**Royal Borough of Kensington and
Chelsea Basements Policy**

Hydrologic Review of Basements,
Publication Planning Policy

Revised Issue | 27 August 2013

Job number 230276-00

Drawing Title
TYPICAL SITE DESCRIPTION

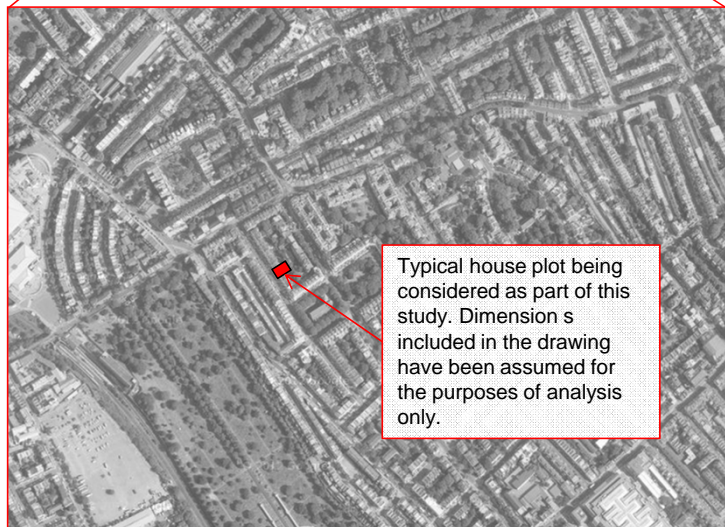
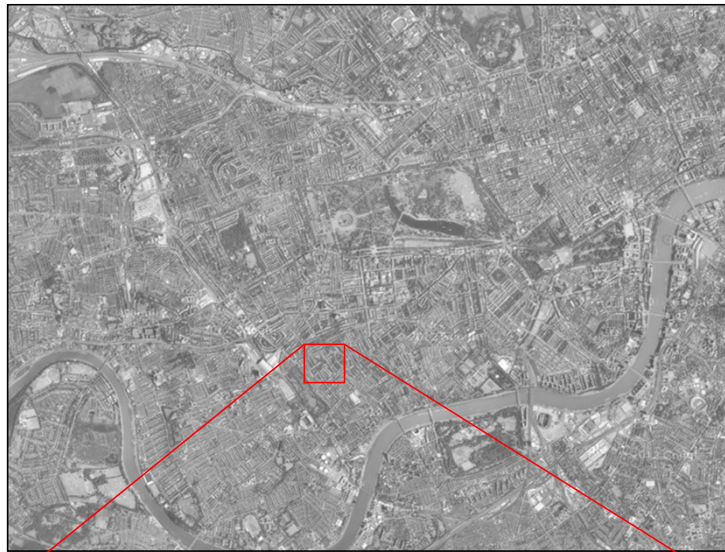
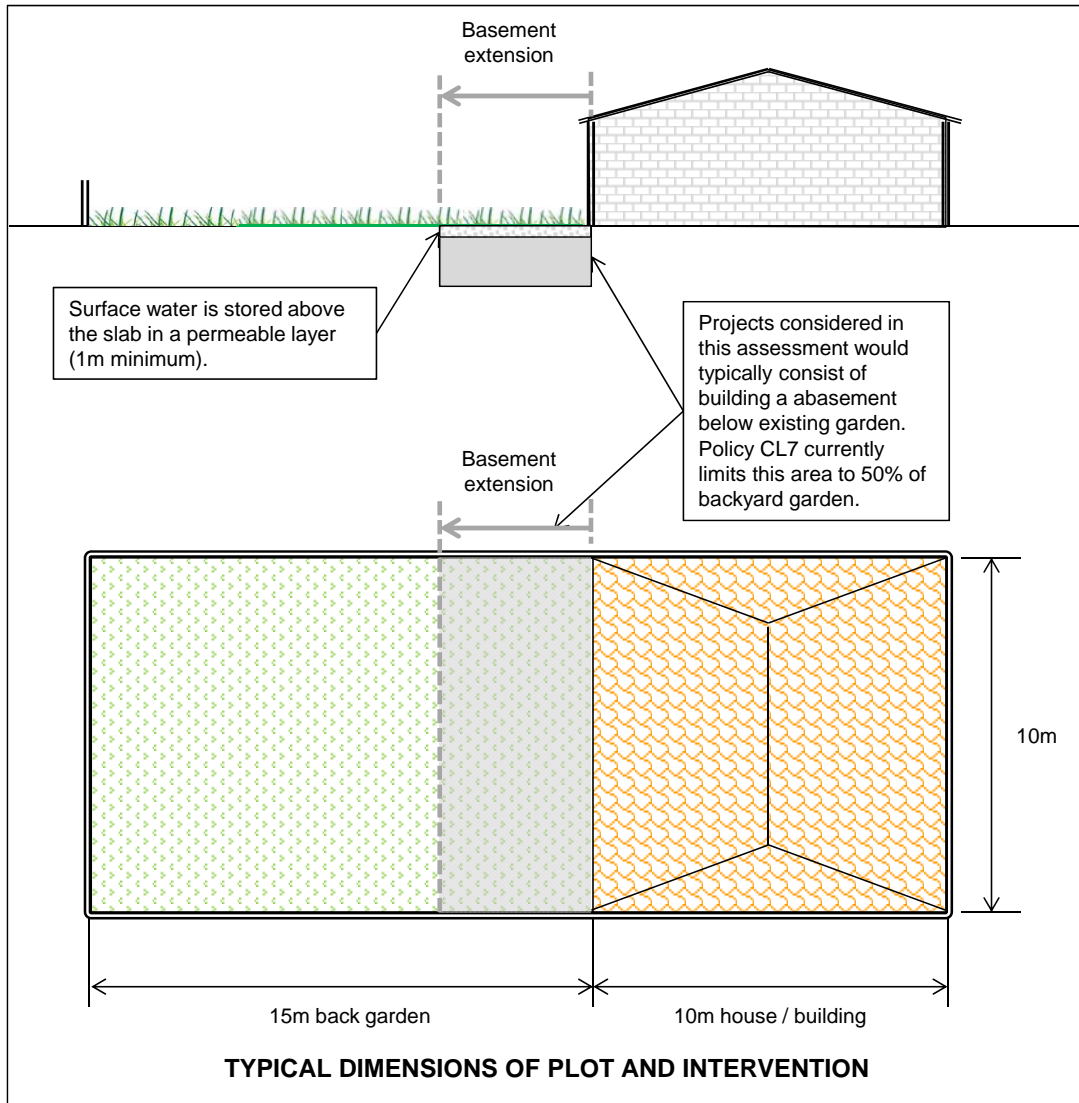
For the purposes of this qualitative hydrological evaluation, a typical site will be used as the basis of assessment and discussion. Figure 3 illustrates the typical layout and section of a site being considered under Policy CL7. This can be described as follows:

- Narrow plot with the residential house at the front and a back garden.
- The boundary of the site follows the extent of the back garden.
- The proposal to be considered would typically involve a basement extension to the property below the garden area.
- The garden is considered to be a lawn or landscaped area that enables natural infiltration of surface water.
- Projects are located either on London Clay or on RTDs. These are the main geotechnical conditions for the Borough as described in Section 2.2.
- Neighbouring properties have similar scale gardens to the side of the site and there is a garden backing onto the site.
- Neighbouring properties have sufficient drainage typical to the area.
- The back garden of the site does not drain to the local public surface water sewer. The only means of discharge is through natural infiltration.

Drawing Title
EXAMPLE STORMWATER MANAGEMENT STRATEGY

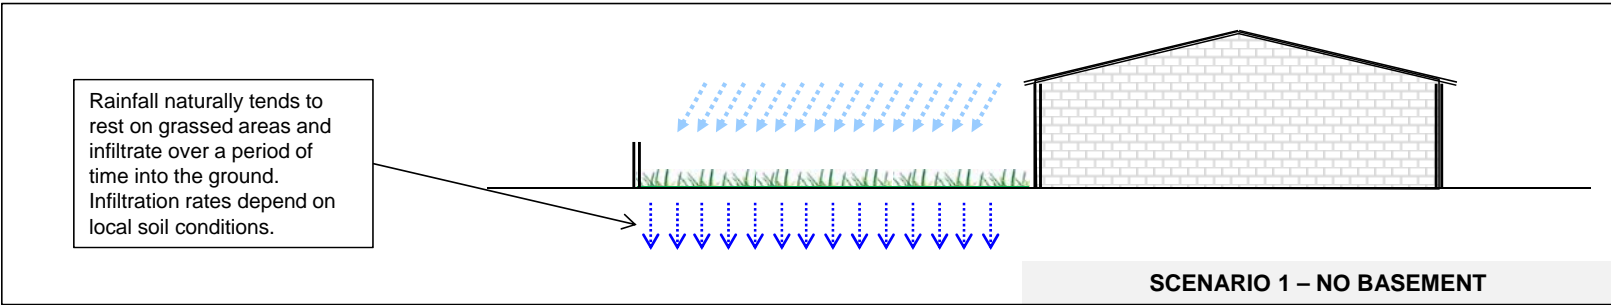
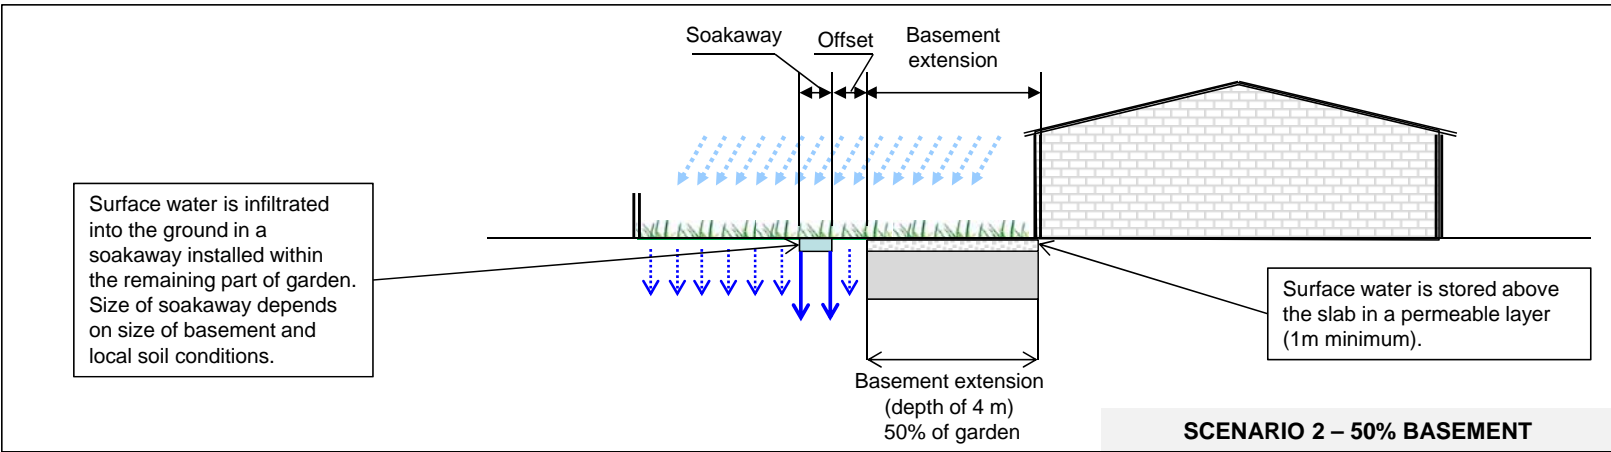
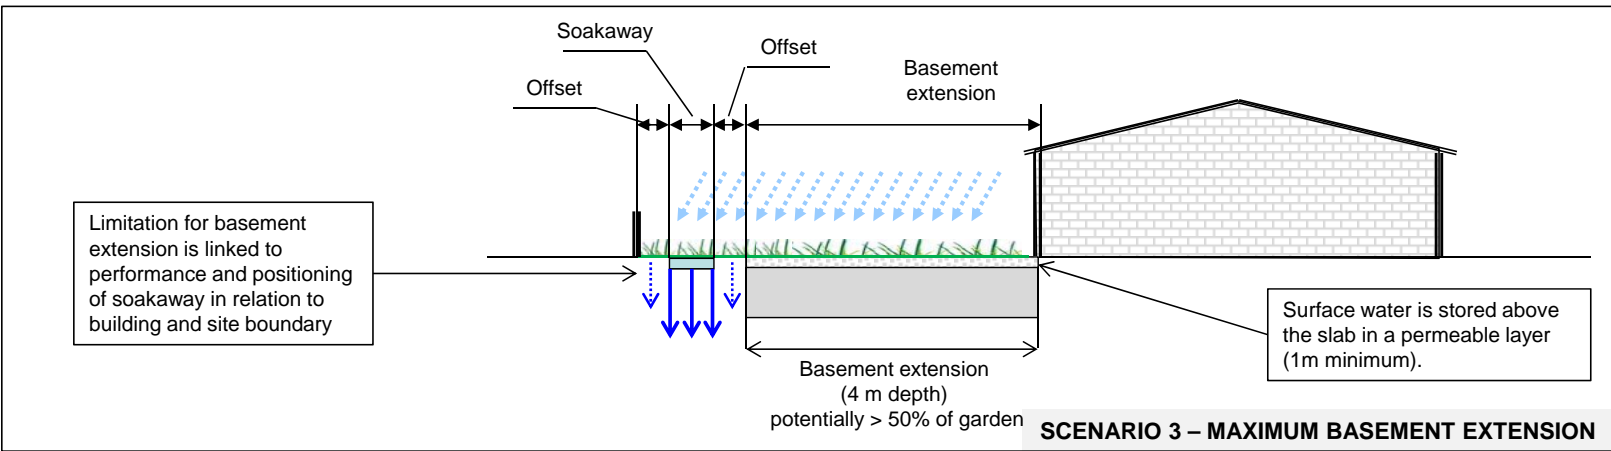
To demonstrate this, we have illustrated three scenarios on Figure 4. The scenarios are as follows:

Scenario 1 – No basement – this is a typical small site as defined above in Section 3, the garden allows natural infiltration of surface water into the ground.

Scenario 2 – 50% rule – a typical small site where Policy CL7 is implemented. A permeable soil storage zone is provided above the basement slab to provide attenuation and a soakaway is provided in the garden area connected to the storage zone to enable a discharge to ground.

Scenario 3 – Maximum Basement Extents – This scenario illustrates a basement extension where the constraints imposed by storm drainage are at the limits of design. Again attenuation is provided in a permeable soil zone above the basement slab and a soakaway is provided in the garden space. However, there is only enough space to position a soakaway within the setback required by building control for properties and the site boundary.

The above scenarios help to illustrate the following:

- Engineering methods are available which can be used to maintain or improve storm water storage and infiltration capacity within the site curtilage.
- A simple limitation of 50% may preclude innovative methods which improve overall drainage conditions within the Borough.
- There is a limit to the amount of garden which can be developed into a basement. To establish this limit, site specific assessment will be needed, a general rule cannot be applied.
